April 8, 1994

93P-424K

Subject: Modifications to the Work Plan for Soil and Ground-
Water Investigation, Dated October 13, 1993,
1432-1434 Harrison Street Site, Oakland, California

Figure 1 : SITE PLAN SHOWING PROPOSED MONITORING WELLS AND GROUND-WATER SURVEY GRAB SAMPLING LOCATIONS

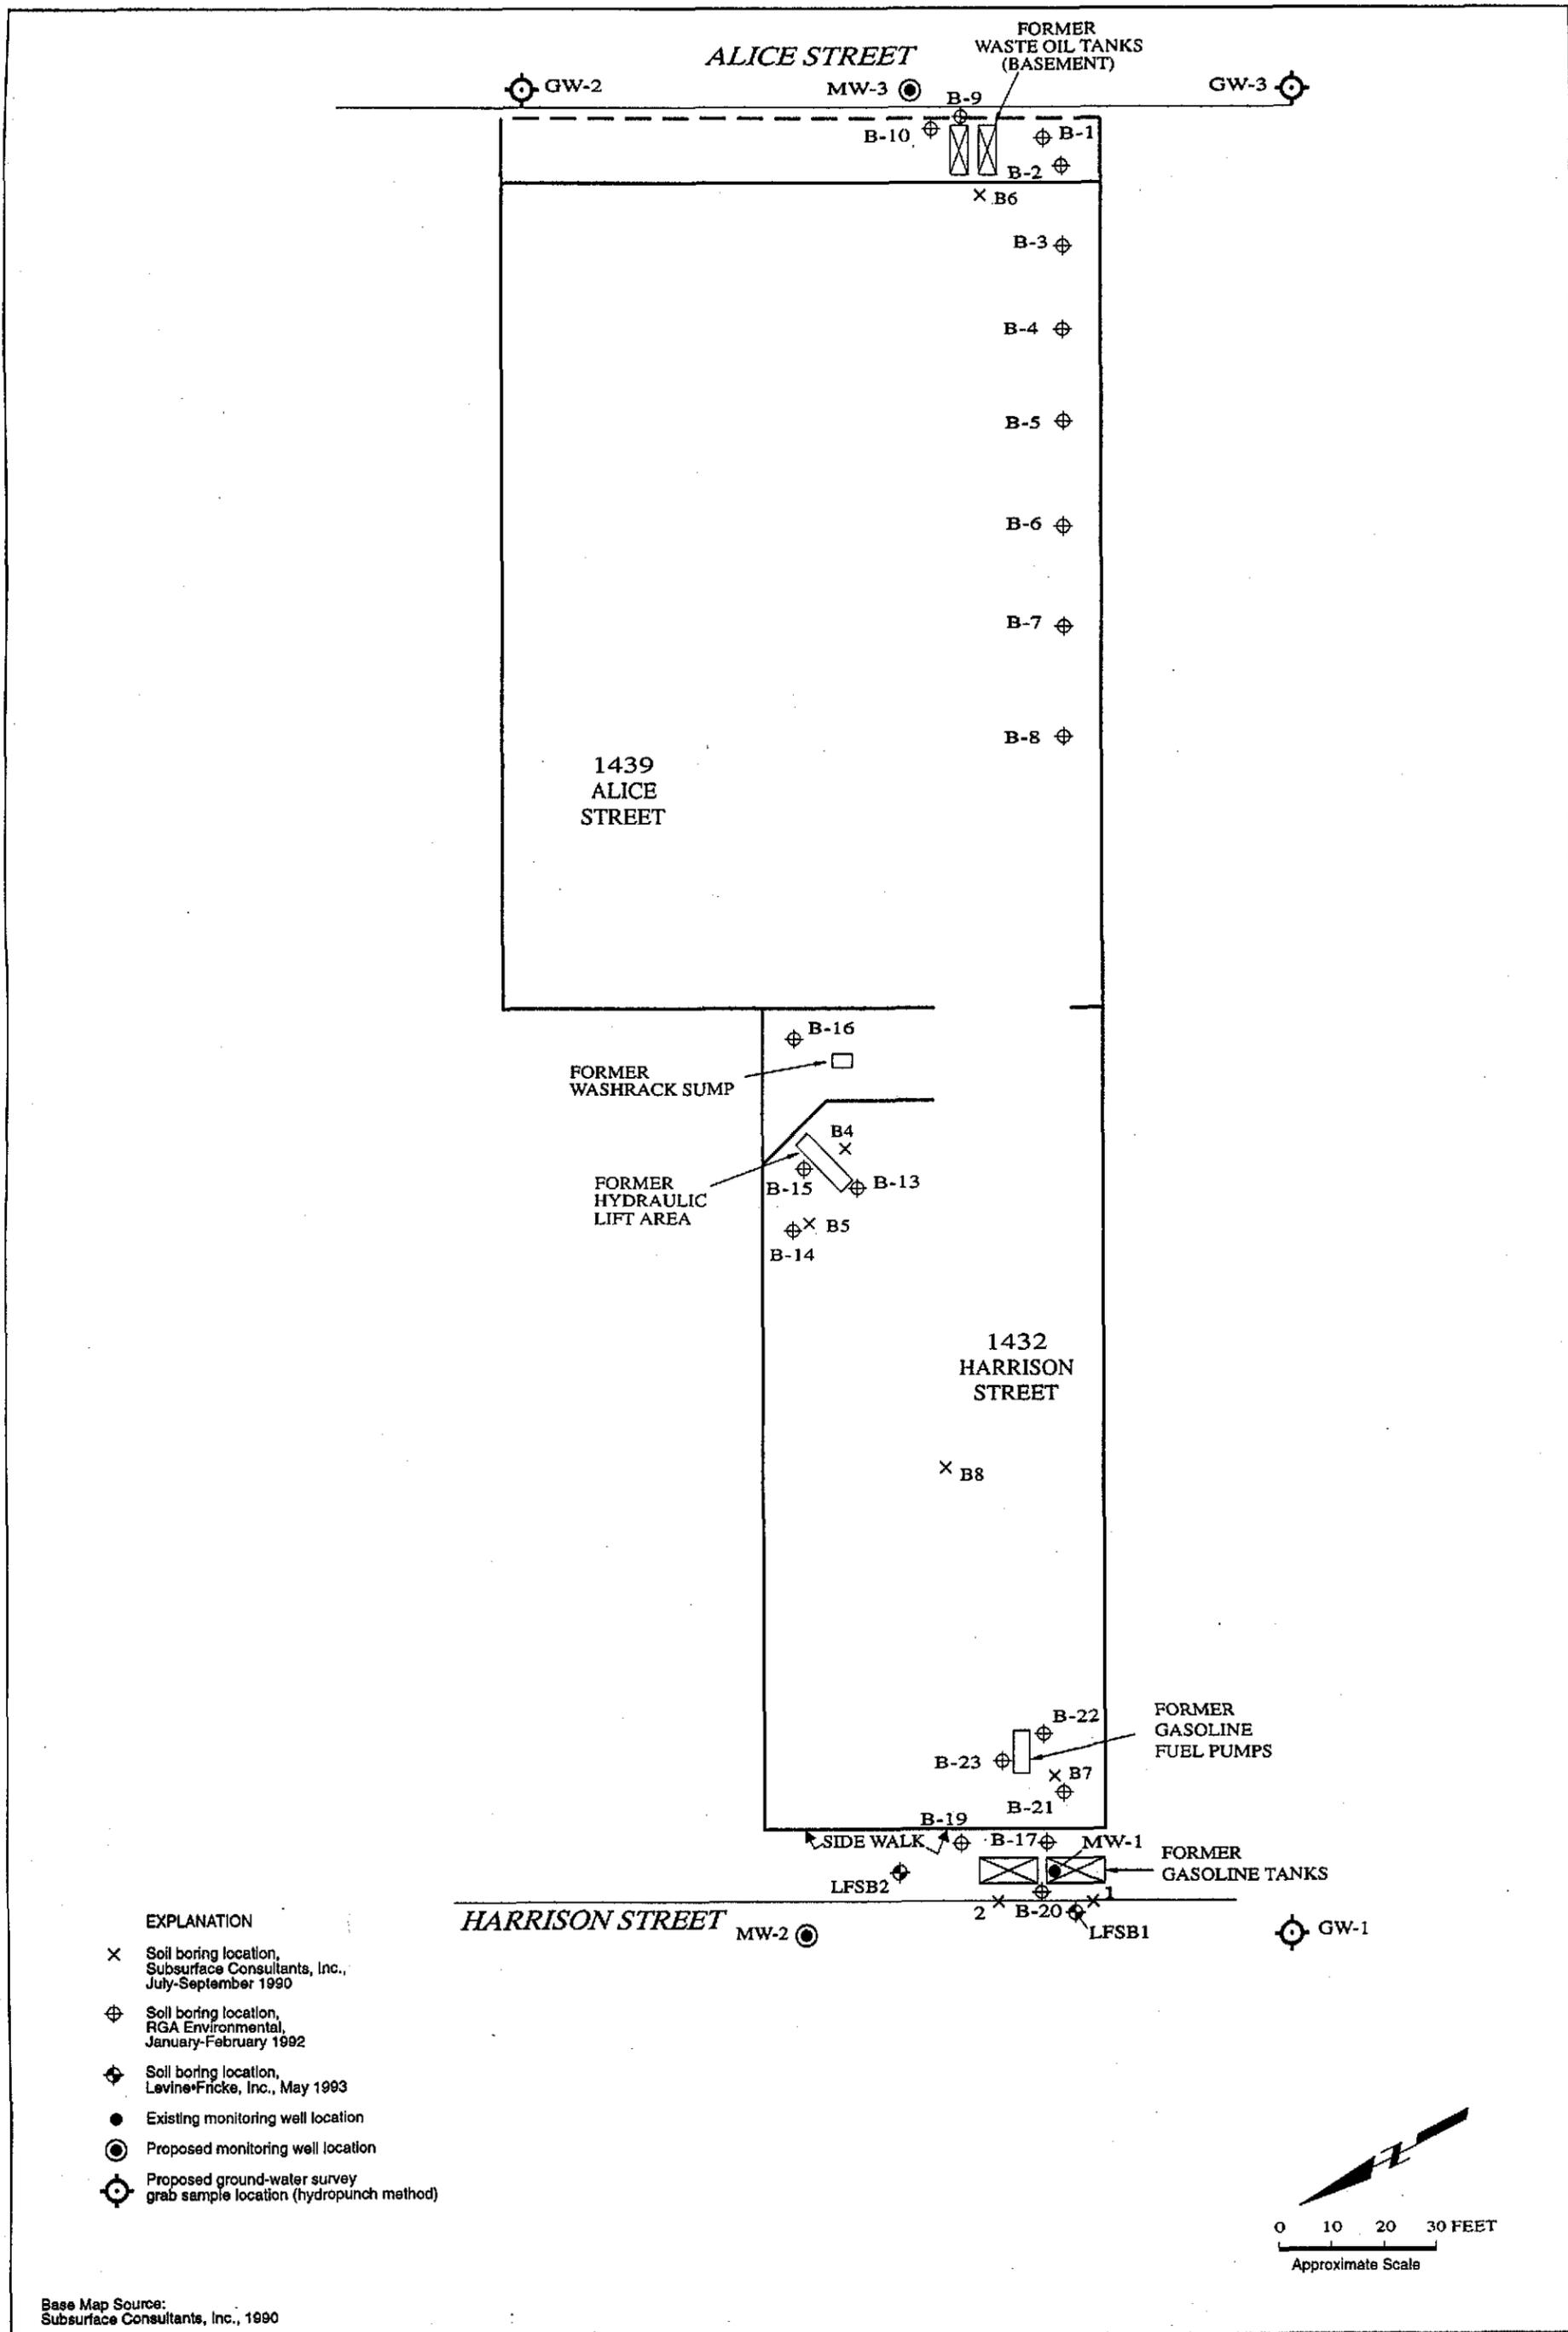
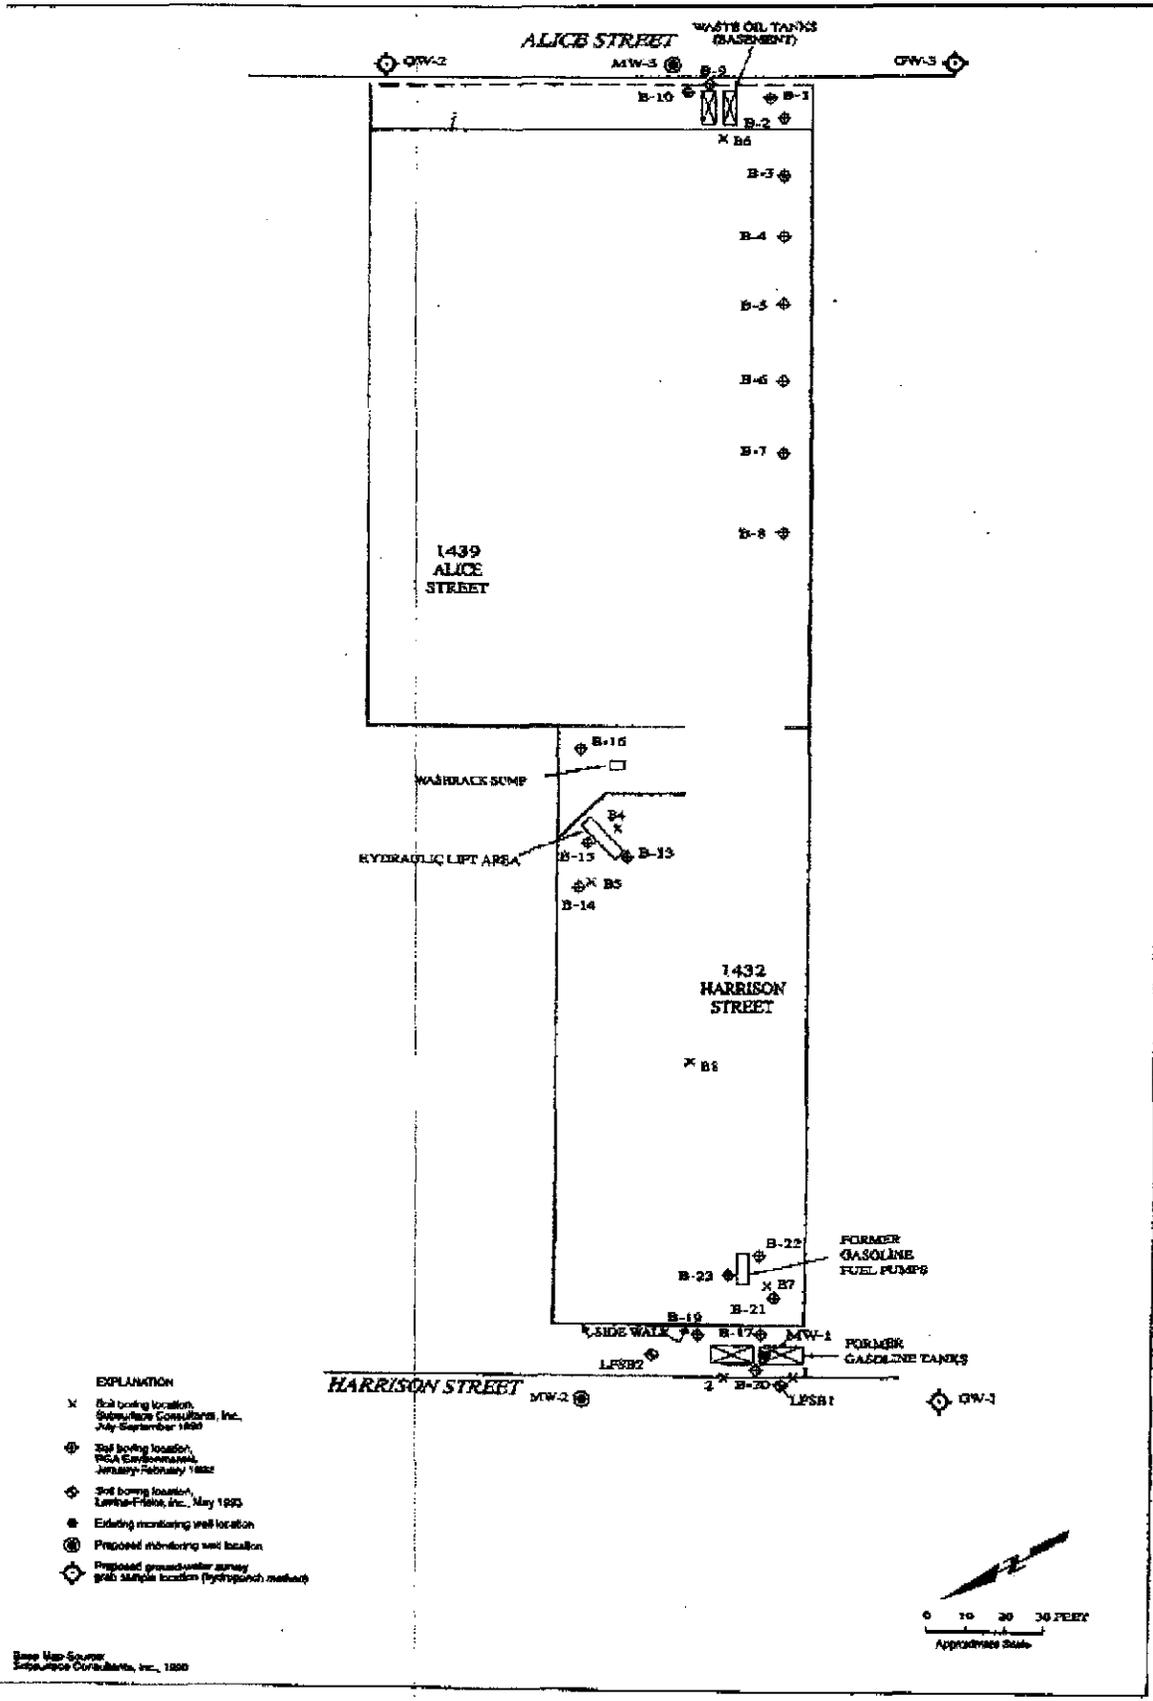
The Phase 1 investigation will consist of conducting a preliminary ground-water survey and drilling two soil borings that will be completed as shallow monitoring wells (Figure 1). At this time, we expect to drill five borings. The three that are not completed as wells will be used to collect grab ground-water samples using the Hydropunch method.

As you know, one ~~shallow ground-water monitoring well~~ was placed in the former gasoline tank excavation. At this time, we ~~propose one additional well on Harrison Street~~ and another additional well on ~~Alice Street~~. Although the exact locations of the two additional wells will be based on field

observations, Figure 1 indicates the proposed configuration of the wells and the borings to be sampled for ground water. The exact locations of the wells and borings will be determined in the field based on the locations of underground utilities and observations during drilling.
